Document Information			
Document #	0201741/02-RCA-0272	**Revision**	
Title	QUARTERLY NOTIFICATION OF CLASS 1 MODIFICATIONS TO THE HANFORD FACILITY RESOURCE CONSERVATION AND RECOVERY ACT (RCRA) PERMIT, DANGEROUS WASTE PORTION (QUARTER ENDING MARCH 31, 2002 - PERMIT CONDITION I.C.3)		
Date	04/09/2002		
Originator	J. HEBDON, R. H. GURSKE, R. D.(ROBY) ENGE	**Originator Co.**	DOE, FH, PNNL
Recipient	L. E. RUUD	**Recipient Co.**	DOEC
References			
Keywords			
Projects			
Other Information

APPENDIX 4B

DETAILED DRAWINGS FOR THE 200 AREA EFFLUENT TREATMENT FACILITY CONTAINER STORAGE AREA AND TANK SYSTEMS

ENGINEERING CHANGE NOTICE

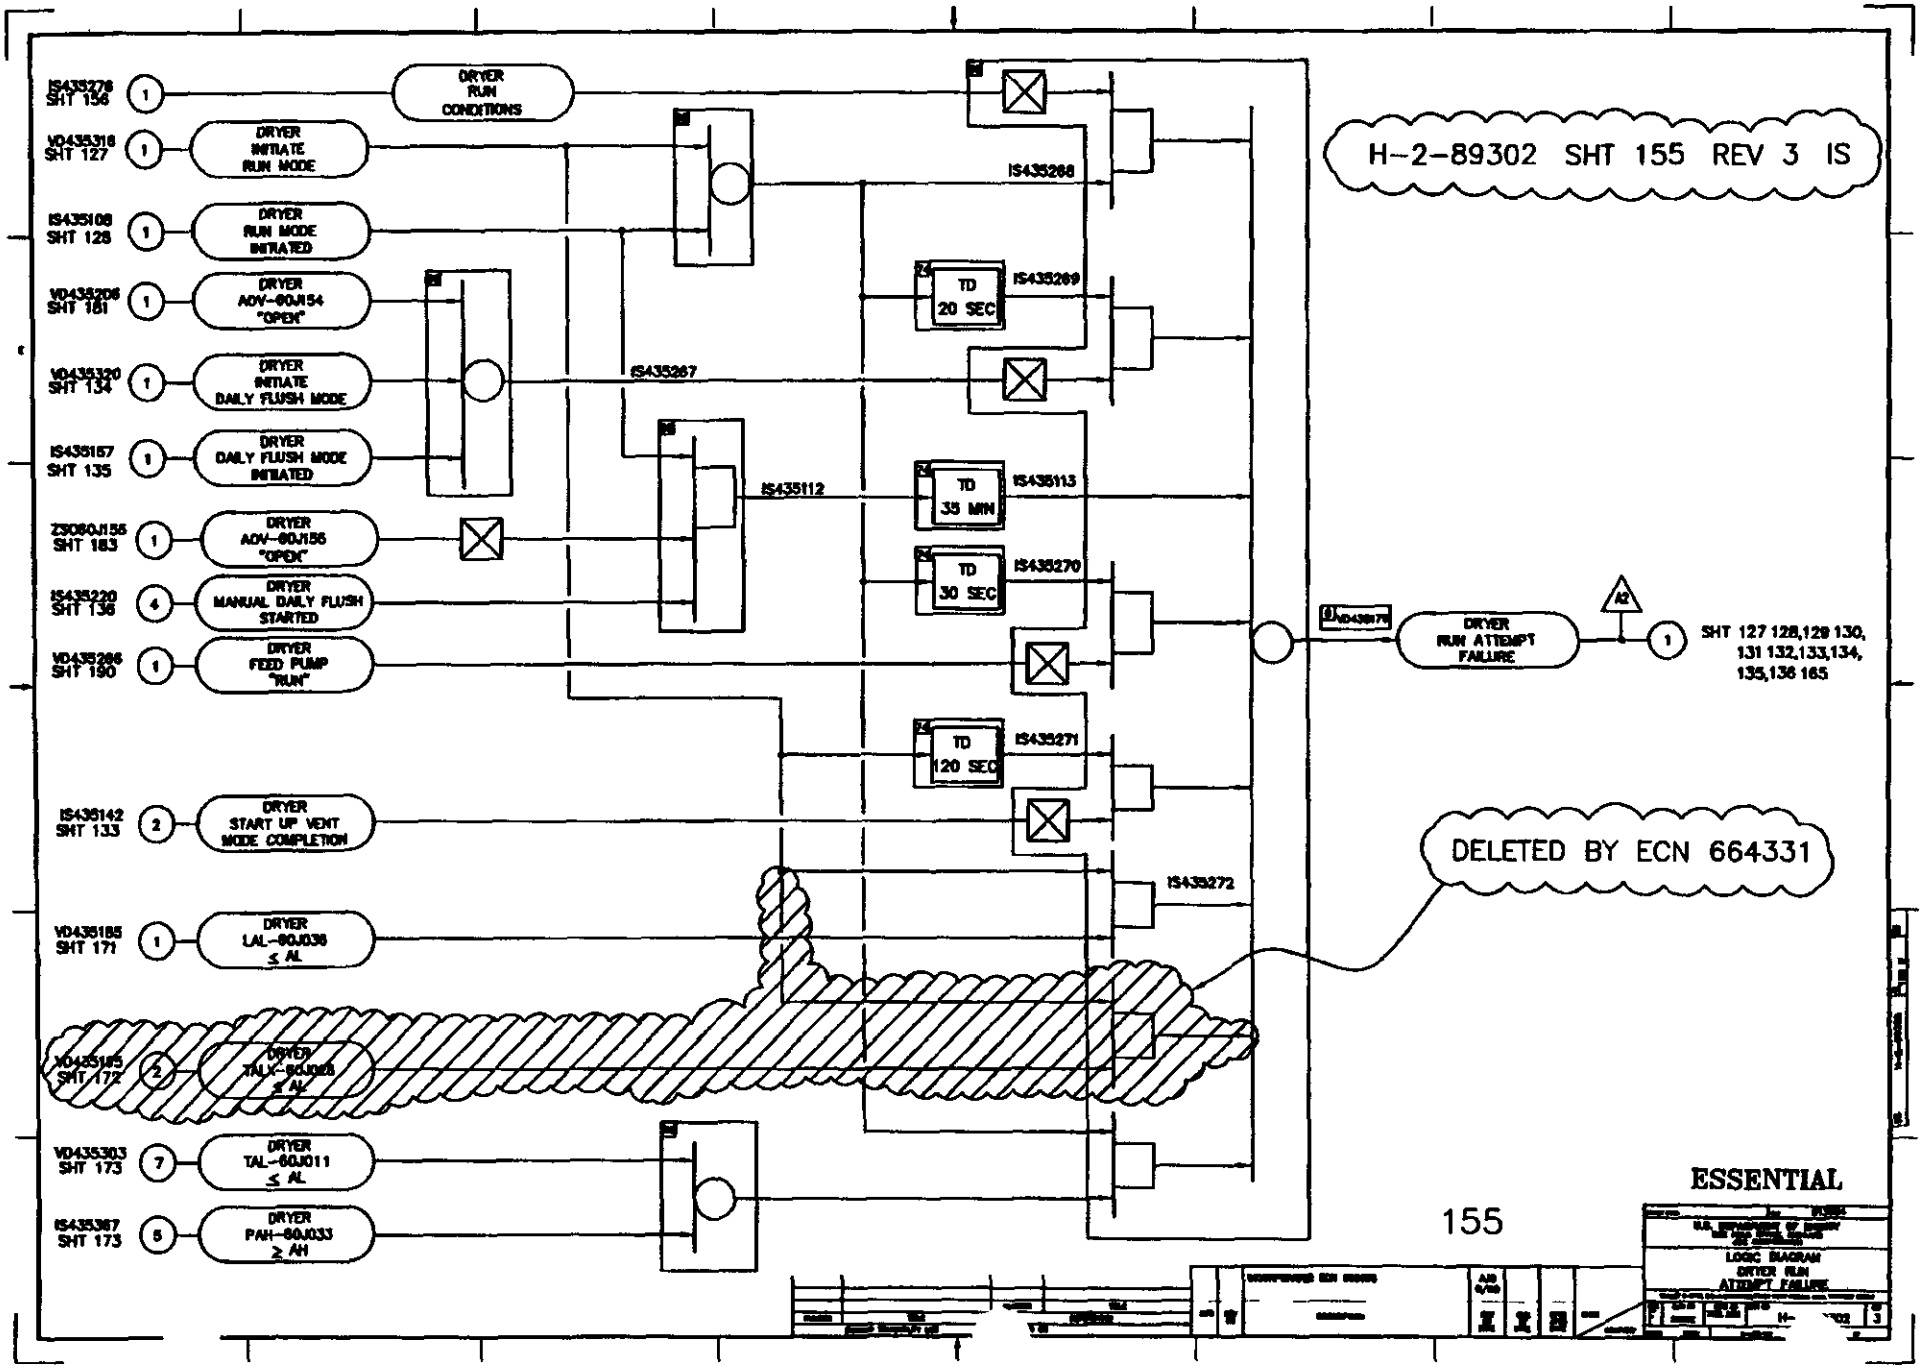
Changes to drawing H-2-89302 SHT 155 is shown on page 8

H-2-89302 SHT 155 REV 3 IS
DELETED BY ECN 664331
IS435278 SHT 156
DRYER RUN CONDITIONS
VD435318 SHT 127
DRYER INITIATE RUN MODE
IS435108 SHT 128
DRYER RUN MODE INITIATED
VD435206 SHT 181
DRYER AOV-60J154 "OPEN"
VD435320 SHT 134
DRYER INITIATE DAILY FLUSH MODE
IS435157 SHT 135
DRYER DAILY FLUSH MODE INITIATED
Z9080J156 SHT 183
DRYER AOV-60J156 "OPEN"
IS435220 SHT 136
DRYER MANUAL DAILY FLUSH STARTED
VD435286 SHT 190
DRYER FEED PUMP "RUN"
IS435142 SHT 133
DRYER START UP VENT MODE COMPLETION
VD435185 SHT 171
DRYER LAL-60J036 ≤ AL
VD435185 SHT 172
DRYER TALX-60J028 ≤ AL
VD435303 SHT 173
DRYER TAL-60J011 ≤ AL
IS435367 SHT 173
DRYER PAH-60J033 ≥ AH
IS435268
IS435269
IS435267
IS435112
IS435113
IS435270
IS435271
IS435272
TD 20 SEC
TD 35 MIN
TD 30 SEC
TD 120 SEC
DRYER RUN ATTEMPT FAILURE
A2
SHT 127 128,129 130, 131 132,133,134, 135,136 165
ESSENTIAL
155
LOGIC DIAGRAM DRYER RUN ATTEMPT FAILURE
